URS CORPORATION – NY
Contract No. C015548
REPUBLIC AIRPORT
RUNWAY 1-19 RUNWAY SAFETY AREA (RSA) IMPROVEMENTS

DATE: May 12, 2016

ADDENDUM NO. 4 TO:

CONTRACT NO. C015548-S13-FRGRSA

LEACHING BASIN DETAL

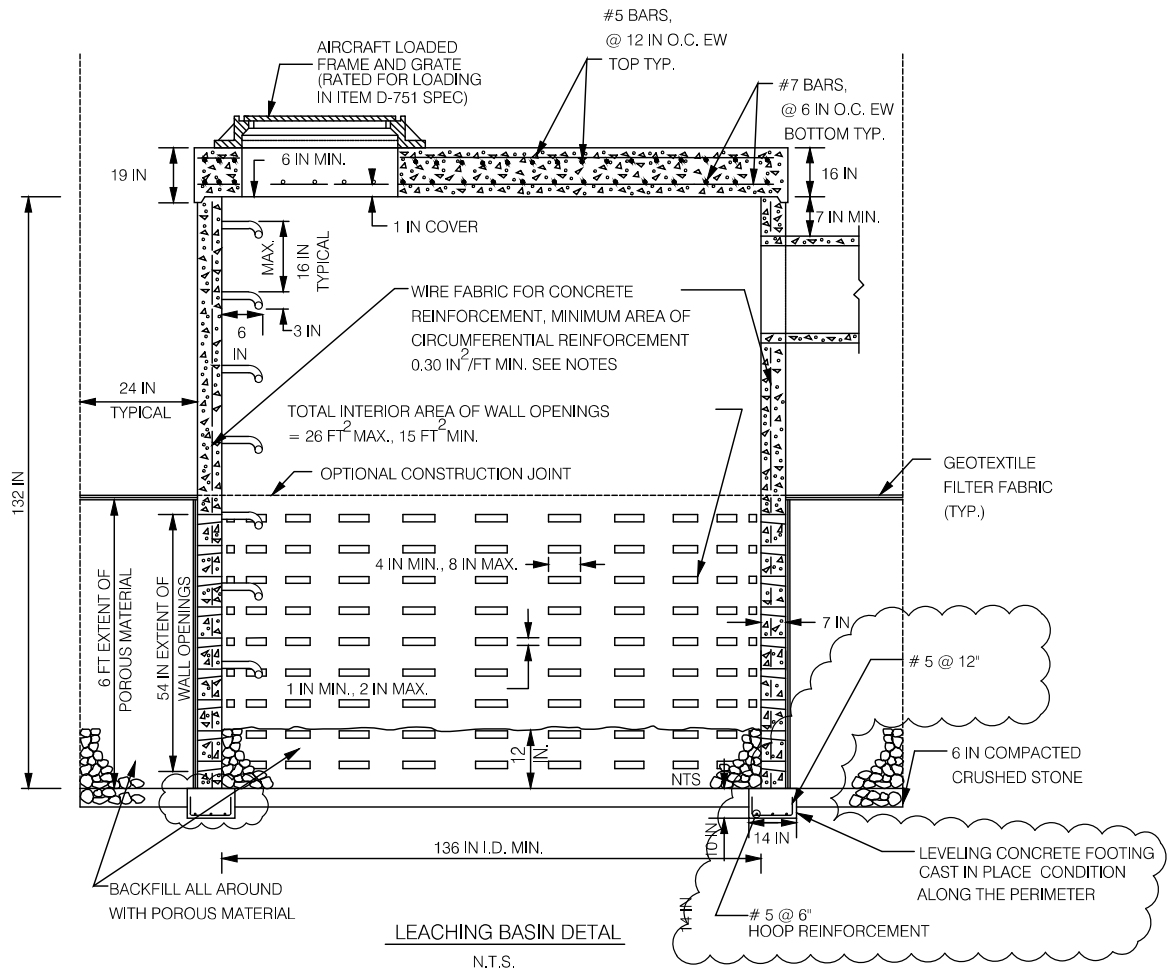
4. Drawing CD-100-A3: Replace Leaching Basin detail with the attached revised detail.

THIS LEACHING BASIN DETAIL SUPERSEDES THE LEACHING BASIN DETAIL FROM DRAWING CD-100-A2
